Exception Request No.: 17
Section: WBR3
Town: Campton
Highway: US 3 (Tier 2)
Station: 2391+50 to 2398+25
Drawing No.: WBR3 C207 to C208
Survey Report Cross Reference No.: WBR3 C203 to C204
Exception Type: Alignment in Pavement

EXCEPTION 17-ALIGNMENT IN PAVEMENT
 NPT WBR3-UNDERGROUND ALIGNMENT
 WBR3-SECTION-STA 2391+50 TO 2394+251
 DATE: 05/20/17

TITLE:
EXCEPTION 17-ALIGNMENT IN PAVEMENT
NPT-WBR3 UNDERGROUND ALIGNMENT
WBR3 SECTION-STA 2391+50 TO 2398+25±
TOWN: CAMPTON

DES: MRR CHK: TDD
 DRW: MRR APR: TMM
 TOWN: CAMPTON
 TRANSMISSION LINE: WBR3
 EXHIBIT A.1

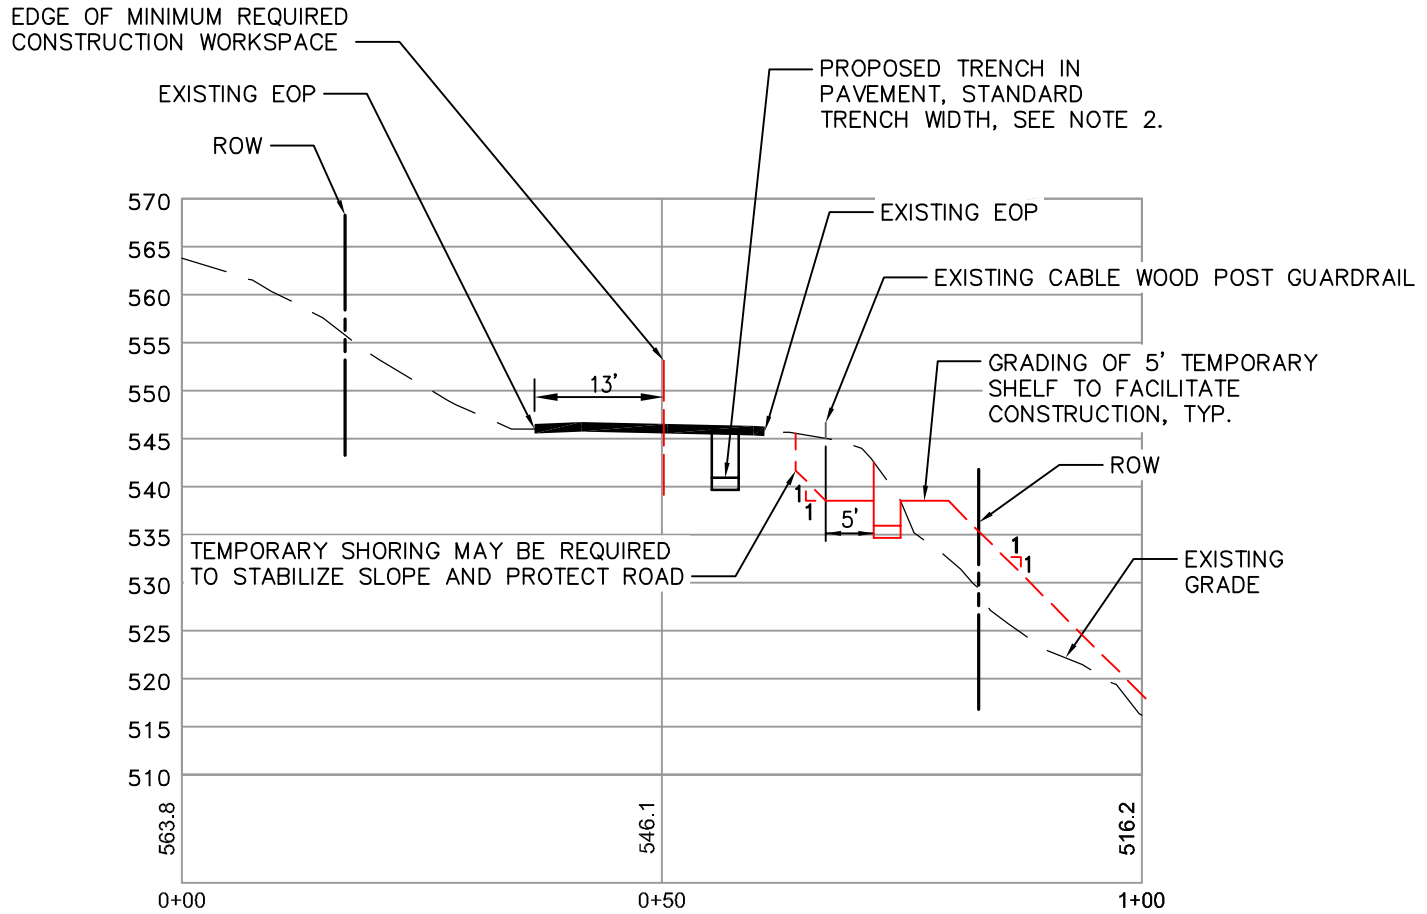
NPT is requesting an exception from the UAM guidelines for the location of the cable trench in the pavement on US 3, Daniel Webster Highway from station 2391+50 to 2398+25 of the NPT WBR3 Underground Alignment. (See Exhibit A.) Due to limited ROW space outside the pavement and beyond the existing guardrail, construction outside the guardrail is not practicable because: (i) if the guardrail is not removed, NPT does not have the necessary property rights to construct outside the NHDOT ROW; (ii) if the guardrail and a portion of the roadway is temporarily removed to allow construction of the ductbank in the slope without extending past the right of way limits for benching, the traffic impacts and cost of this construction method are substantially greater than the proposed installation. The proposed alignment is located beneath the pavement at a 5-foot offset from the guardrail consistent with NHDOT's request to avoid future conflicts with guardrail repairs or replacement, or disruption to the existing guardrail system.

Note: NPT is requesting an exception for the portion of the alignment from station 2391+50 to 2398+25±. (See Exhibit A.) In the original permit drawings, NPT proposed an alignment within the pavement for a longer portion of the roadway in this area. In response to NHDOT comments, NPT has reduced the length of the alignment within the paved area, which will require relocating four utility poles from station 2401+00 to 2405+75. The revised alignment will be reflected in revised drawings to be submitted at a later date.

EXHIBIT NO.: B

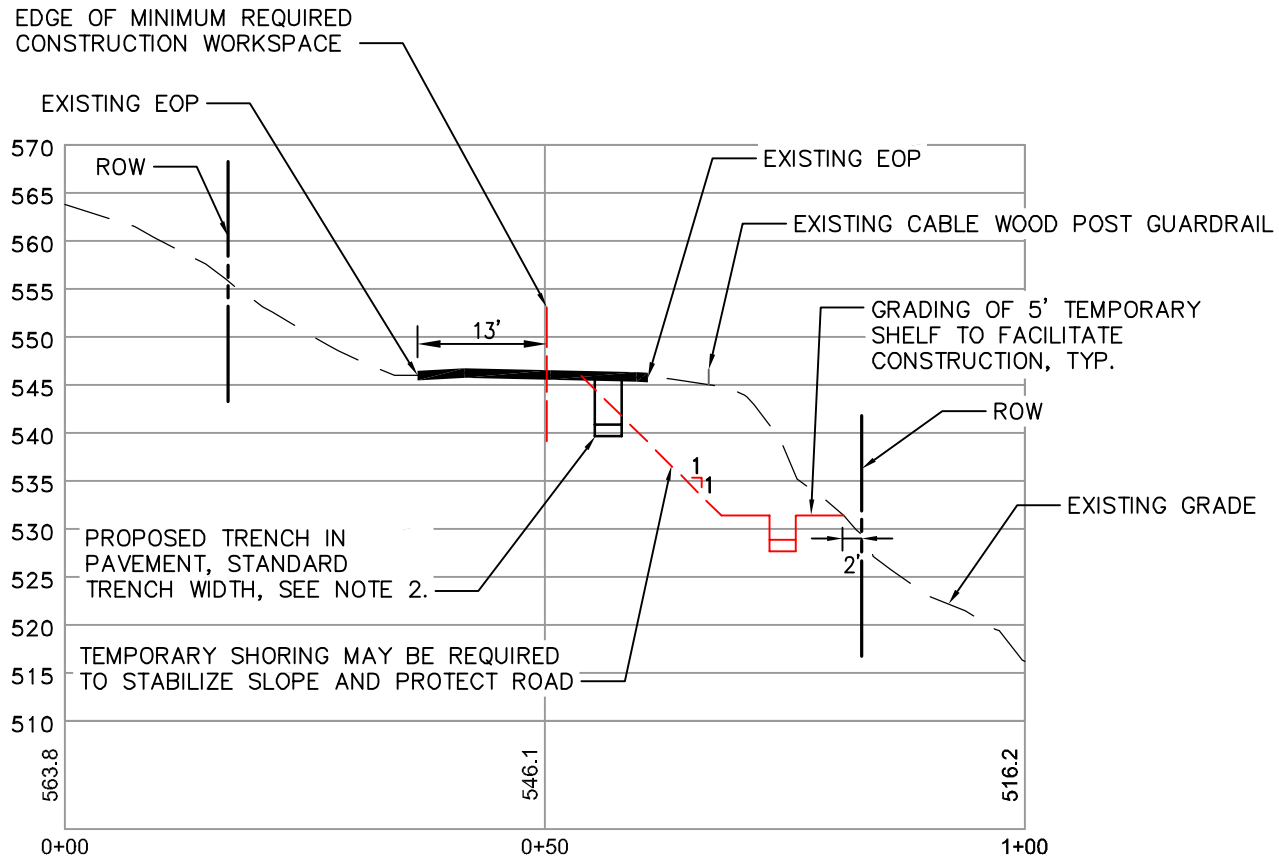
The roadway alignment at this location is constrained by guardrail on the north side of US 3 with moderate to steep slopes on the outside of the guardrails. Consequently, the steep slopes behind the guardrail, combined with NHDOT's requested offset of 5-feet from the existing guardrail, would result in significant constructability issues, including the need for benching into the side slope to create a level and safe working area. The modified side slopes would extend beyond the ROW limits. (See Exhibit B.)

1. THE TRENCH LOCATION SHOWN IN RED IS NOT PROPOSED AND IS INTENDED TO DEMONSTRATE CONSTRUCTABILITY ISSUES.
2. TRENCH WIDTH AS SHOWN TO BE MAINTAINED USING TRENCH JACKS AND SHEETING.
